3.0 DESIGN STATEMENT

179 – 181 High Street Hampton Hill

Pre-app

Project	179-181 HIGH STREET, HAMPTON HILL		
Drawing	PROPOSED MASSING		
Drawing No.	179HS-03	Scale	@ A3
Date	01.09.2015

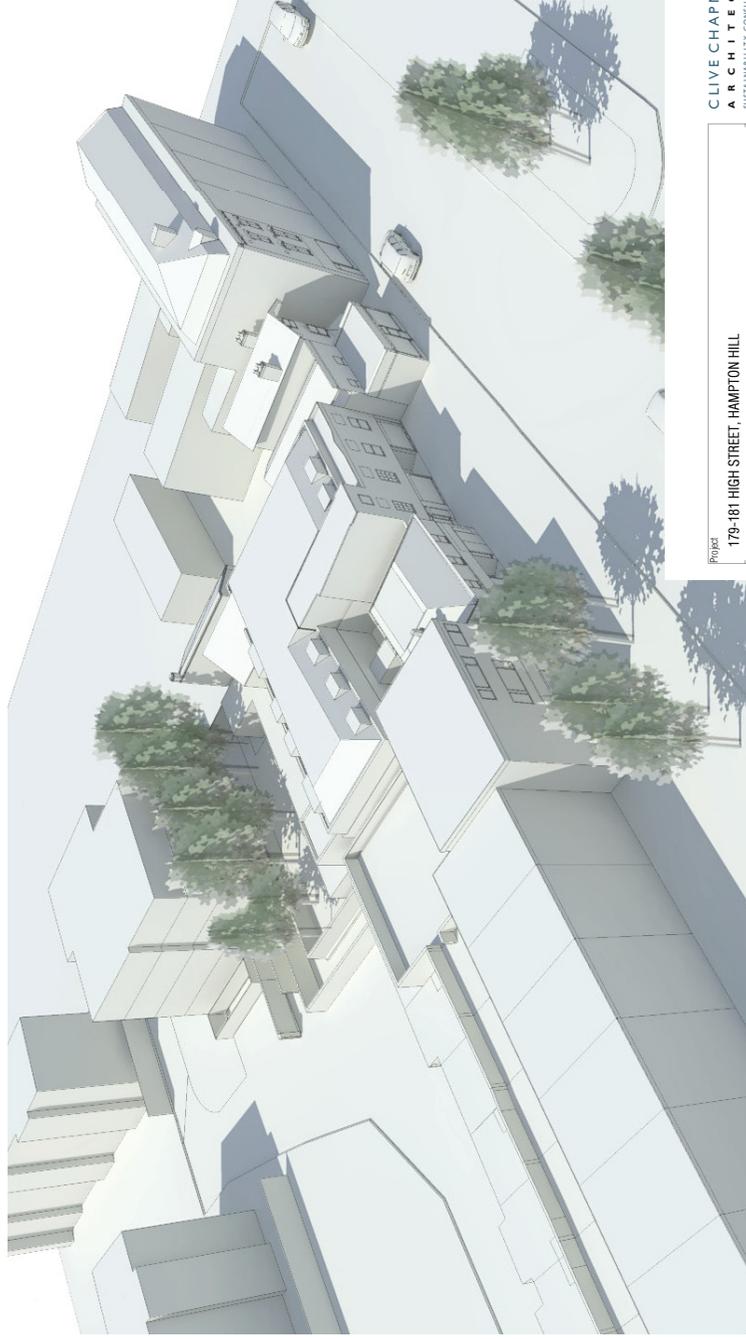
“In relation to the proposal at roof level, the proposed massing drawing indicates that there may be some visibility of the proposed taller elements to the rear of the site on the High Street frontage. Some concern about this in relation to the hipped roof BTM in particular at 179 - it will be important to keep any visual impact as low as possible.”

In relation to the proposal at roof level, the proposed massing drawing indicates that there may be some visibility of the proposed taller elements to the rear of the site on the High Street frontage. Some concern about this in relation to the hipped roof BTM in particular at 179 - it will be important to keep any visual impact as low key as possible.

We have developed a computer model and tested the visibility of the scheme from the street. We have satisfied ourselves that the

proposed development will have minimal impact on the existing BTM. By the time the extension is visible (directly in front of the buildings) it is a long way back in the site. This can be seen on the proposed street views drawing no 179HS-19.
